UNITED STATES  
DEPARTMENT OF THE INTERIOR  
BUREAU OF LAND MANAGEMENT

FORM APPROVED  
OMB NO. 1004-0135  
Expires: July 31, 2010**SUNDRY NOTICES AND REPORTS ON WELLS**  
*Do not use this form for proposals to drill or to re-enter an abandoned well. Use form 3160-3 (APD) for such proposals.***SUBMIT IN TRIPLICATE - Other instructions on reverse side.**

**\*\* BLM REVISED \*\* BLM REVISED \*\* BLM REVISED \*\* BLM REVISED \*\* BLM REVISED \*\***

**CHANGES TO ORIGINAL APD**  
**Nearburg Producing Company OGRID #15742**  
**Huber Federal #6H**  
**API #30-015-39765**

Project: Eddy County, NM (NAD27 NME) (10)  
Well: Huber 3 Fed #6H  
Wellbore: Lateral #1  
Design: Design #2 (10°/100')

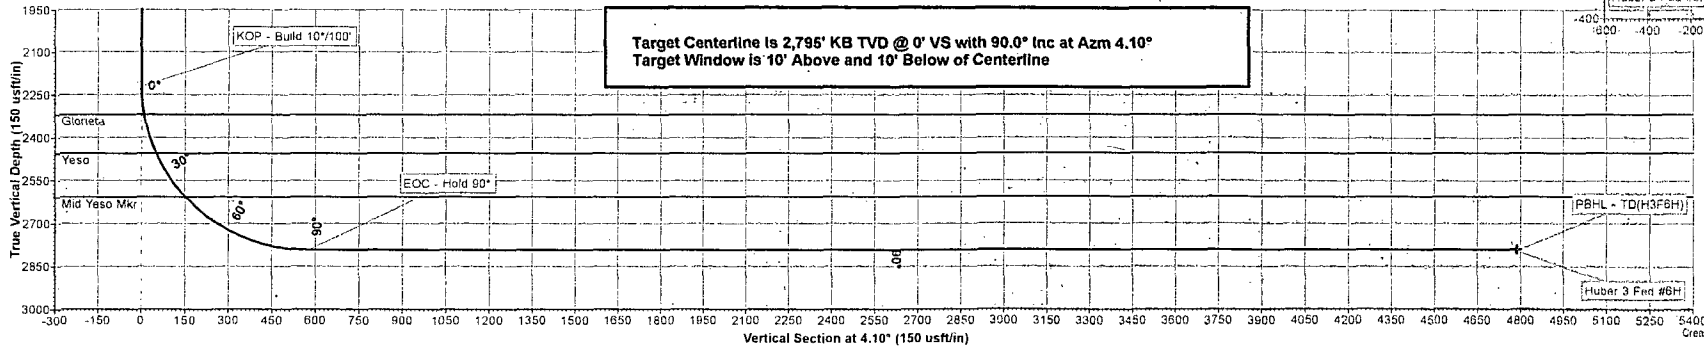
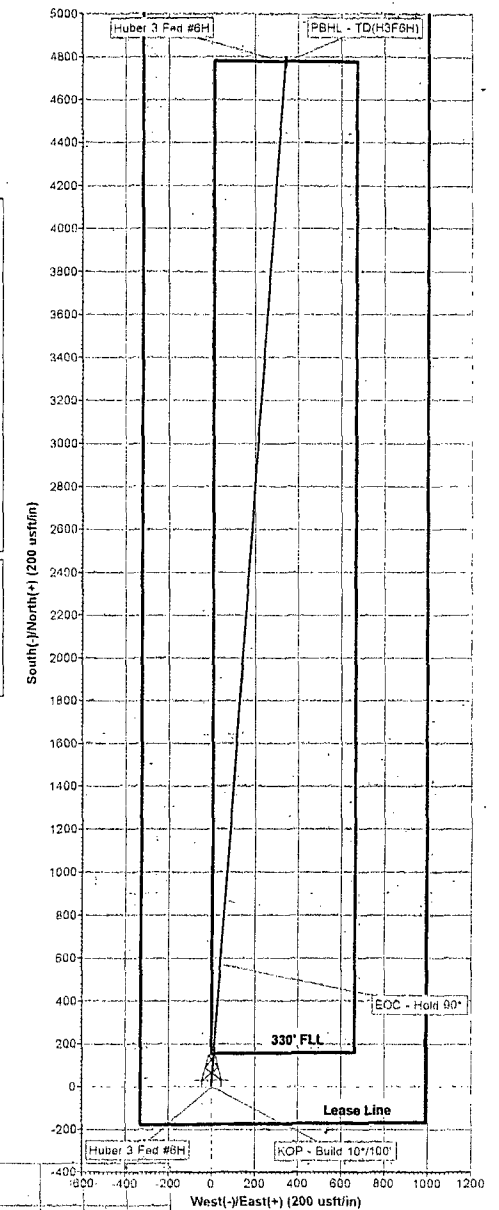
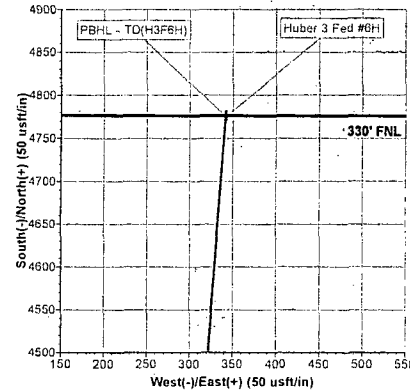
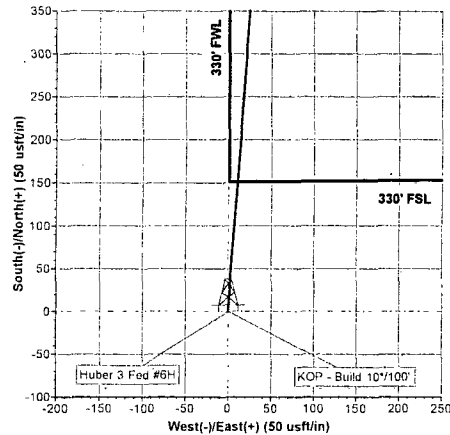
Revised TVD: 2795'  
Revised MD: 7336'  
Kickoff Point: 2222'  
Start Date: December 2014

Please see attached revisions to original APD:

1. Drilling Program
2. Contact List
3. Directional Plan

— Design #2 (10°/100')
